SUBJECT: Limerick Generating Station, Units 1 and 2  
Information for Auxiliary Systems Branch (ASB)  
Regarding Technical Specification Surveillance  
Requirement 4.6.1.4

Attached is a draft change to FSAR Figure 6.7-2 which is being made as a result of the referenced telecon.

FSAR FIG. 6.7-2  
MSIV-LCS PROCESS  
DIAGRAM

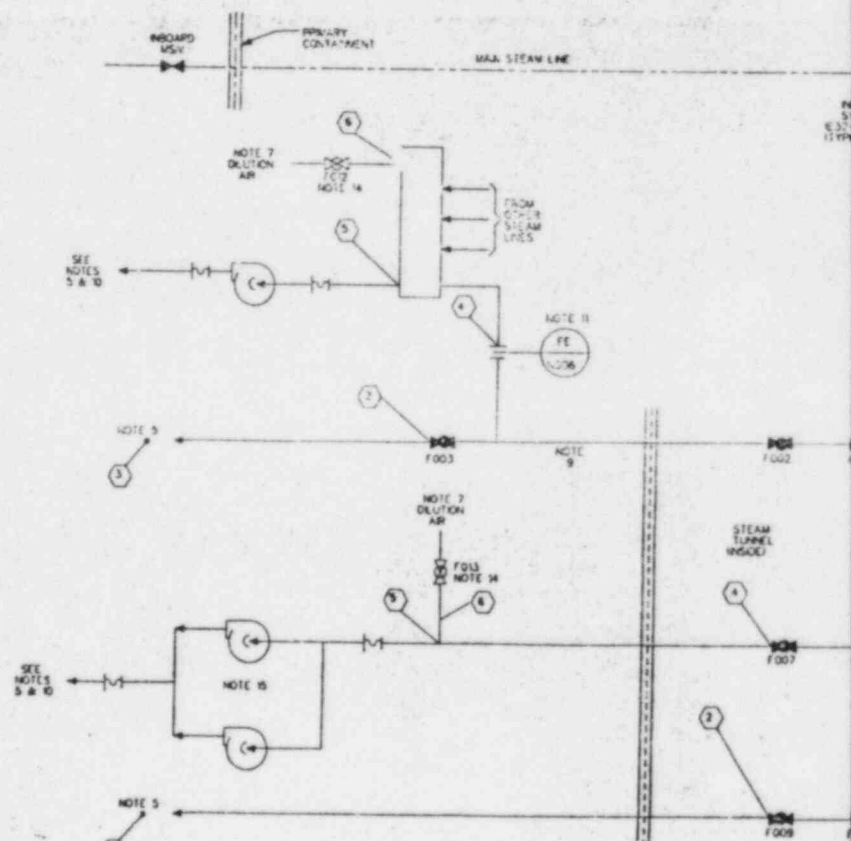
The information contained on this draft FSAR change will be incorporated into the FSAR, exactly as it appears on the attachment, in the revision scheduled for October 1984.
